SERVICE BULLETIN

INSPECTION OF THE OIL FILTER

FOR ROTAX® ENGINE TYPE 912 AND 914 (SERIES)

SB-912-045

(see fig. 1)

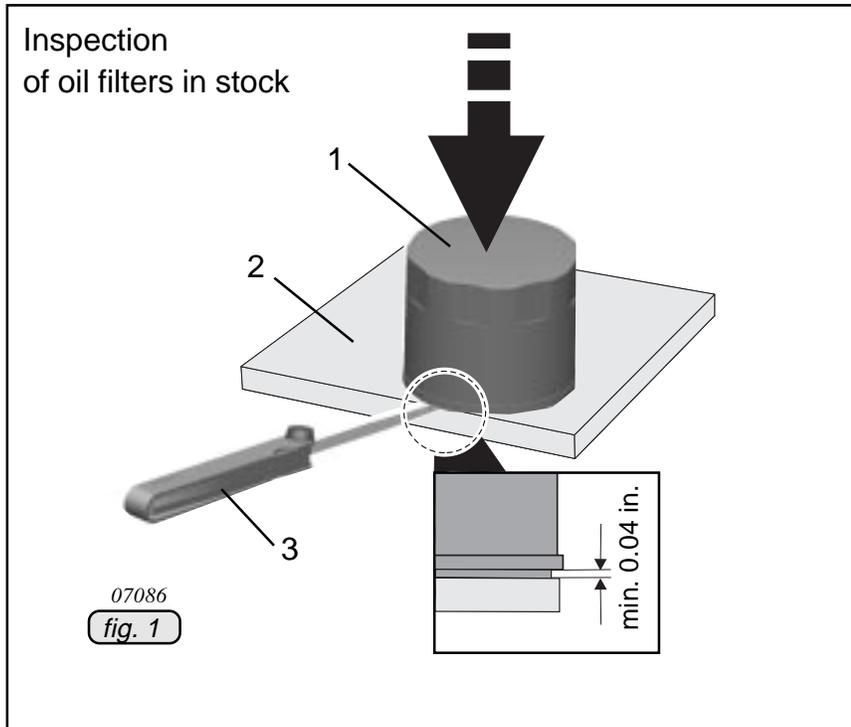
- Place oil filter (1) on an even base plate (2).
- Press down oil filter by thumb in order to fully fit sealing ring into its groove.
- With pressure still applied measure the projection of sealing ring (in this case the gap between base plate and oil filter bead) with a feeler gage (3). If the projection is smaller than **1,0 mm** (0.04 in.), otherwise replace the oil filter immediately.

(see fig. 2)

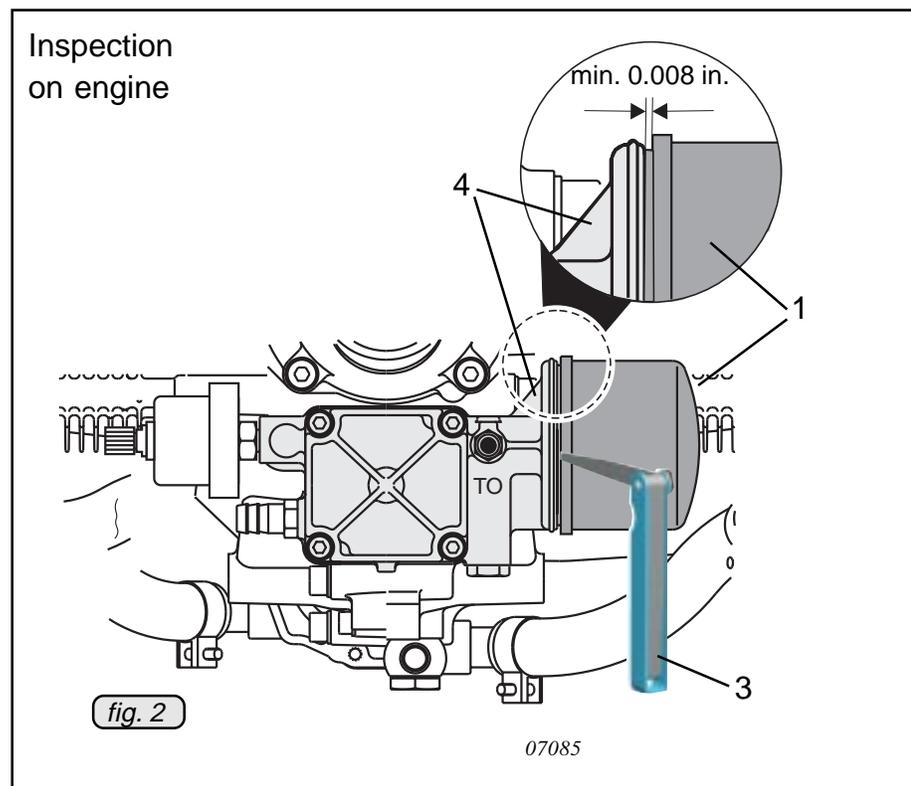
- Measure the projection of sealing ring (in this case the gap between oil pump housing and oil filter bead) with a feeler gage (3).

If the projection is smaller than **0,2 mm** (0.008 in.), replace the oil filter immediately.
